**Subject**  
**Roof Opening Panel Shield Slides Back and Forth Whilst Driving and Braking**

**Model: S-TYPE**

**Section: 501-01**

S501-22: This Technical Bulletin has been issued to address customer concerns of the roof opening panel shield sliding back and forth while driving and braking.

Fig. 1

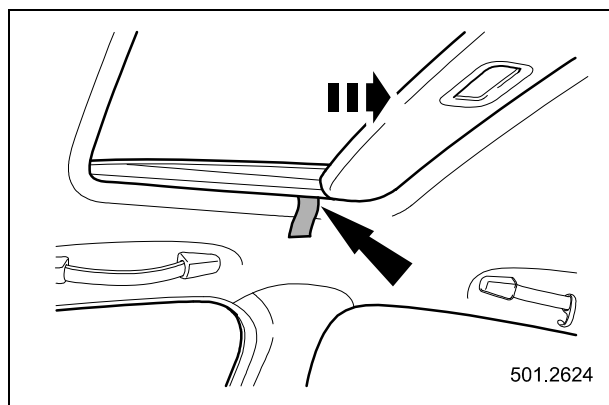
- 1 Open driver's door.
- 2 With the roof opening panel in the closed position. Slide the roof opening panel shield fully rearward.
- 3 Mark with masking tape on the headliner where the roof opening panel shield leading edge has stopped (see Fig. 1), both sides of the roof opening panel.

Fig. 2

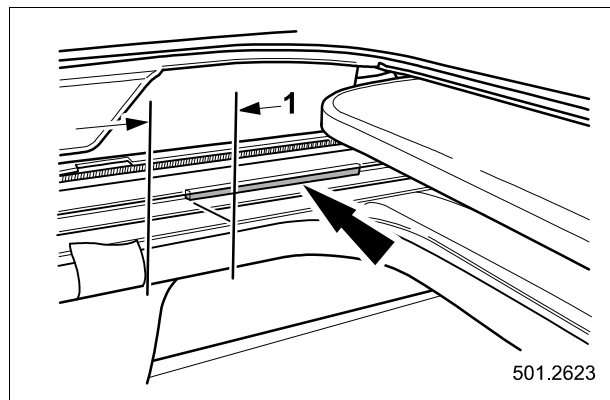
- 10 Apply the Velcro strips into both the right and left roof opening panel shield tracks of the frame assembly. With the front edge of the Velcro 25mm behind the tape mark (see Fig. 2).

**Note: The roof opening panel shield track is the upper of the two visible tracks.**
